# MEMORANDUM

**FILE NO.:** SUB2006-00041(Final); SUB2005-00003 (Preliminary)

**PROPOSAL:** Final plat approval for Erin Manor III Subdivision; an application to subdivide approximately 20 acres into 78 lots.

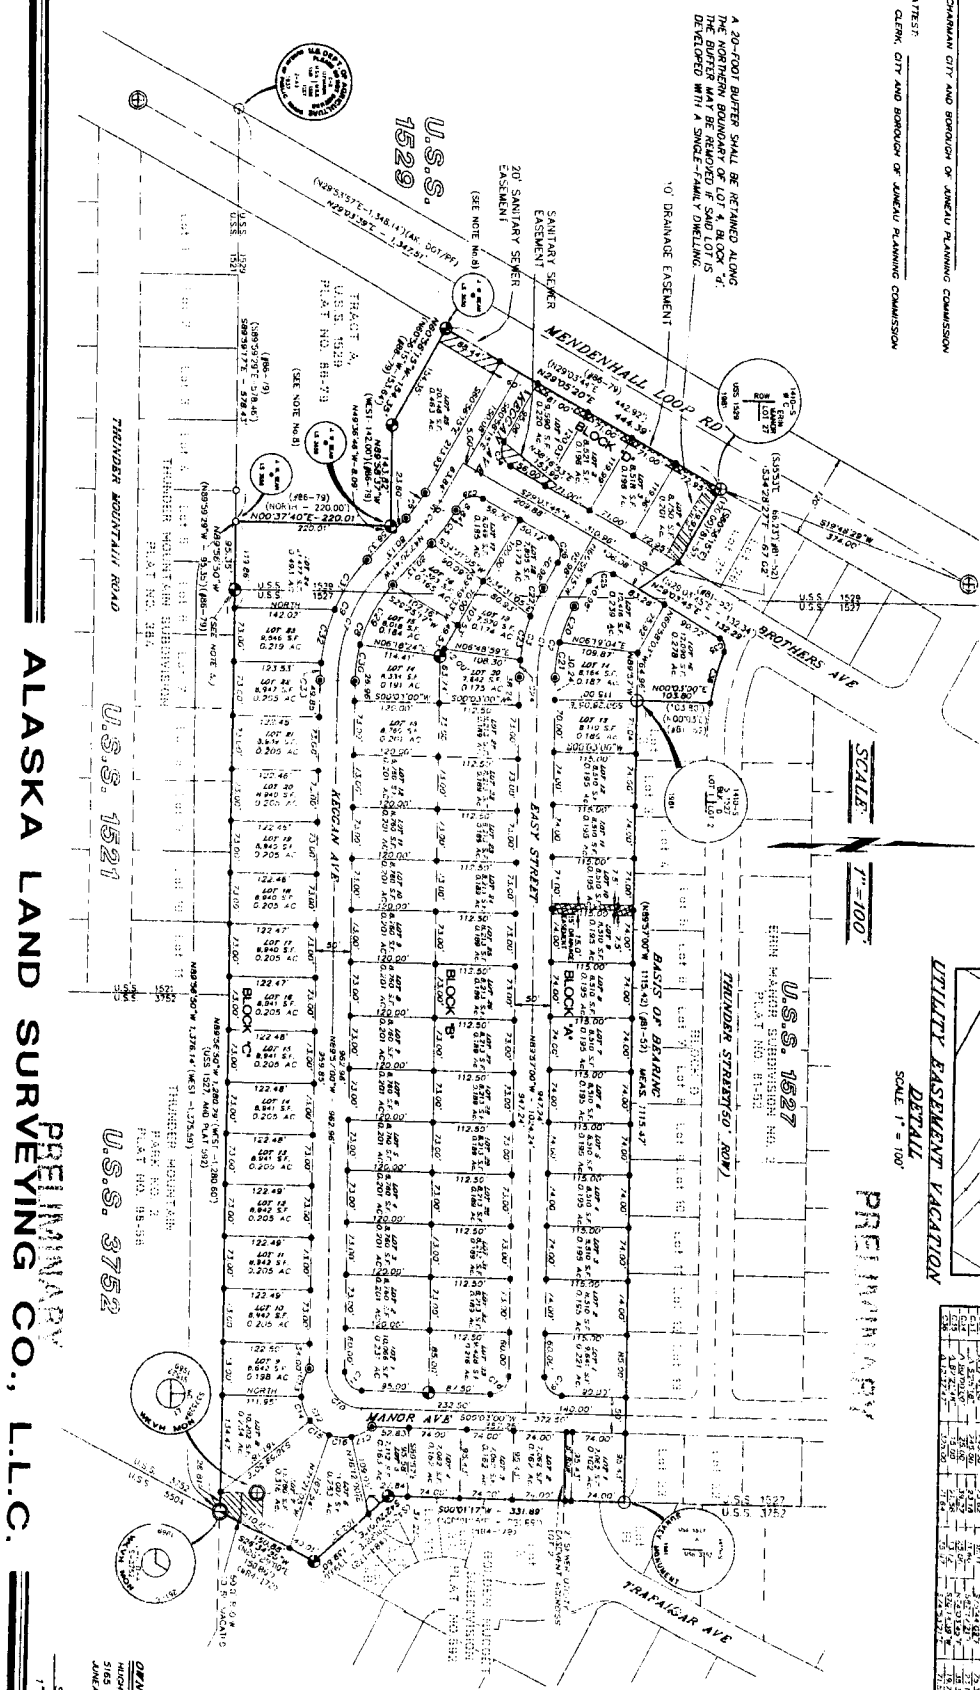
The applicant has submitted a final plat with 78 lots. The effect of this, due to the smaller size of the lots in the final plat, has been to reduce the number of “duplex lots” from 28 to 4 within the D-5 –zoned portion of the subdivision, hence limit the number of duplexes that might otherwise have been constructed. Dwelling unit calculations are set forth below:

The overall dimension of the subdivision, with the exception of the new Lot 16, Block ‘A’, remains the same. Access to and from the subdivision remains the same. Potential density in the subdivision can be expected to be reduced, as there is now a much higher ratio of single-family lots to duplex lots. The character of the neighborhood will be predominantly single-family.

The final plat contains this condition as note # 7.

Brothers Avenue has been re-named Keggan Avenue at this location. The final plat contains a plat note (# 9) that reads, "Direct vehicle access for Lot 1, Block "D" and Lot 25, Block 'C' is prohibited onto the first 150 feet of Keggan Avenue extending from the Mendenhall Loop Road."

The final plat implements this condition with language that states, "A 20-foot buffer shall be retained along the northern boundary of Lot 4, Block 'D'. The buffer may be removed if said lot is developed with a single-family dwelling."

The final plat shows an 8-foot-wide pedestrian right-of-way connecting Trafalger Avenue and Manor Avenue, located between Lots 1 and 2, Block 'C'. A two-foot-wide no-build easement runs alongside the 8-foot right-of-way in Lot 2, creating a ten-foot-wide connection between Trafalger Avenue and Manor Avenue to accommodate utility and pedestrian access. The connection meets Planning Commission intent to co-locate the sewer utility easement and the pedestrian access within a single 'connection.'

1. The 8-foot paved, pedestrian right-of-way between Trafalger Avenue and Manor Avenue must be constructed before building permits are issued for Lot 1 and Lot 2, Block 'C'.
